MARIN COUNTY BICYCLE COALITION

I am writing to express several concerns that MCBC has with the current design of the E. Blithedale Avenue Rehabilitation Project, particularly with regard to the design of the bicycle facilities. My three primary concerns are outlined here.

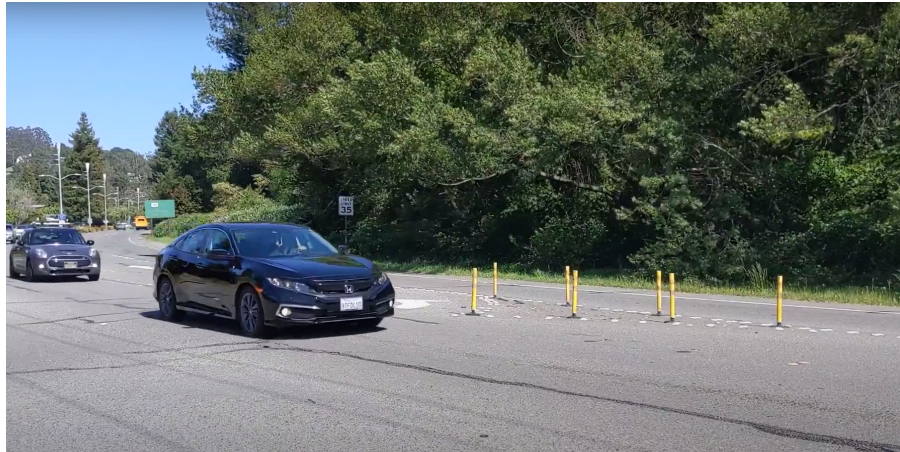
This week we learned that the City plans to delineate the bike lanes (they can hardly be called “separated,” much less “protected”) with flex posts. This is very disappointing to us at MCBC, because we feel that such a treatment would be a far cry from achieving an “all ages and abilities” standard that the towns and cities of Marin County should aspire to when creating bike facilities, especially those intended for use by children traveling to and from school.

One does not have to look far and wide to see broken or flattened flex posts, which are so-named because they are intended to yield to car bumpers rather than damaging them. It should go without saying that a barrier designed to protect car paint *will not protect vulnerable riders* from an errant driver crossing into the bike lane. Whatever is used, it should be highly visible and not be easy to run over without noticing. Below is a photo of existing flex posts used on E. Blithedale. Would those posts make anyone feel safe from the passing cars?

MCBC urges Mill Valley to separate the planned bike lane with something more substantial than flex posts. Ideally this separation would be something that would actually prevent a car from entering the bike lane, such as concrete barriers or planters. Barring that, we feel strongly that the bike lane should be separated with K-71 plastic bollards and/or rubber barriers, the more modern standard used in new bike lanes in cities as diverse as San Rafael, Fremont, and San Jose.

Bike Lane and Buffer Width

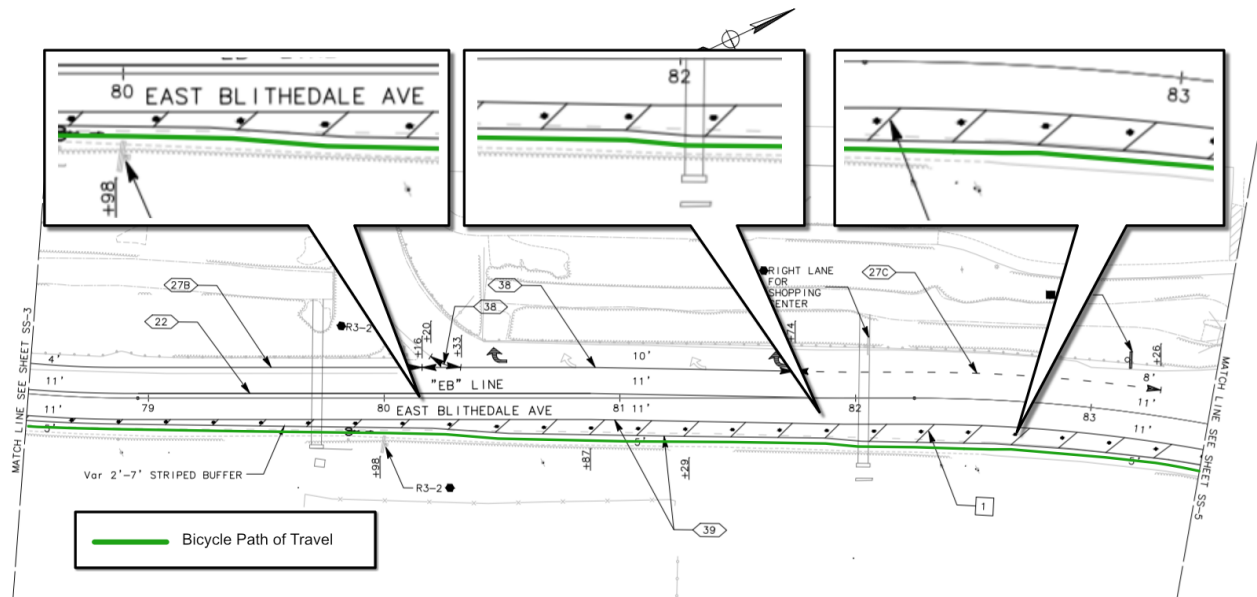
A Class 4 separated bike lane must be at least 5' wide with a 2' buffer, the area in which the vertical separators are located (e.g. bollards, flex posts, etc.). While these represent the *minimum* allowable widths, those areas may be wider. In fact, the preferred width of a protected bike lane, per the National Association of City Transportation Officials (NACTO) is 7', especially in an uphill direction or on a busy bike lane.

As shown in the plans below, the proposed design maintains the eastbound bike lane at a minimum 5' width throughout, while the buffer ranges from 2'-7'. The westbound lane also maintains a minimum of 5' with the buffer ranging between 2'-13'. To analogize, this is like designing a 10' car lane even while the roadway shoulder is as wide as 15'.

This choice is perplexing, as it squeezes riders into a small space over the whole corridor, rather than only in the maximally-constrained areas. Faster riders will have a difficult time passing those traveling more slowly, and children biking to school will not be able to ride next to one another.

Additionally, this strict adherence to the 5' minimum bike lane results in an awkward path of travel for riders, as the striping veers sharply back and forth to follow the edge of the road, as shown below.

MCBC recommends that, in the areas not maximally constrained, the buffer first be increased to 3', at which point the bike lane should be widened to allow easy passing, up to a width of 8'. Attention should be given to ensuring that the 'bike path of travel' remains a gentle curve, like that for automobiles, rather than jerking back and forth.

Eastbound Ashford Avenue left onto Meadow Drive

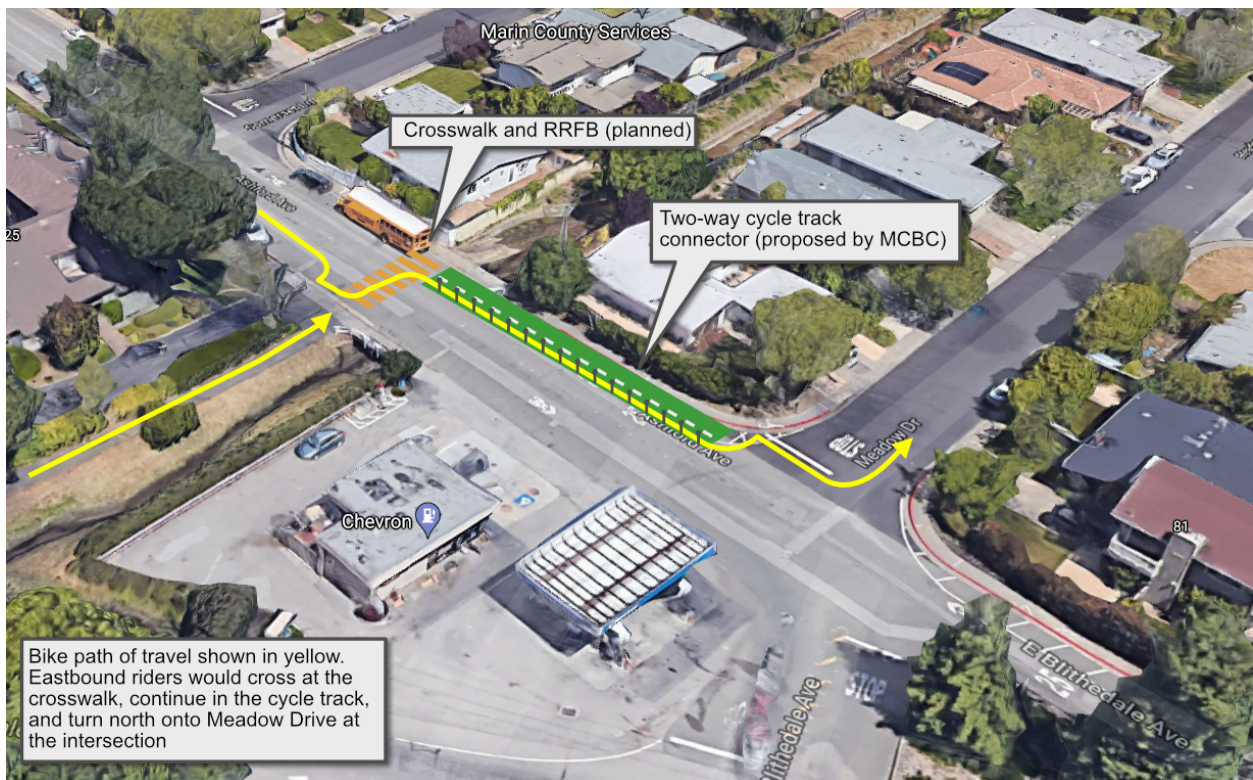
As a result of feedback from the BPAC, the City decided to provide a crosswalk across Ashford Avenue connecting Meadow Drive to the creek path immediately west of the Chevron station. This is a welcome addition. However, additional feedback provided by MCBC and seconded by members of the BPAC noted the lack of an accommodation for cyclists traveling eastbound on Ashford Avenue turning left (north) onto Meadow Drive (a Class 3 bicycle route, as described by the Bicycle/Pedestrian Master Plan).

Because westbound drivers coming off of E. Blithedale will have the right-of-way while navigating an s-curve, there is no clear place for a rider turning left onto Meadow Drive to wait. Do they sit in the middle of the intersection? Do they pull into the Chevron parking lot and try to cross the street perpendicularly?

At the 3/31 BPAC meeting, I urged city staff to address this issue. One potential solution would be to create a two-way cycle track connector on the north side of Ashford Avenue between Meadow Drive and the proposed crosswalk (as shown below). Eastbound riders could cross at the crosswalk before continuing to Meadow Drive. This design may not prove feasible, but no other alternative was offered, and the plans before the council do not include an easy path of travel for eastbound riders turning from Ashford onto Meadow. I recommend that the final designs address this existing deficiency.
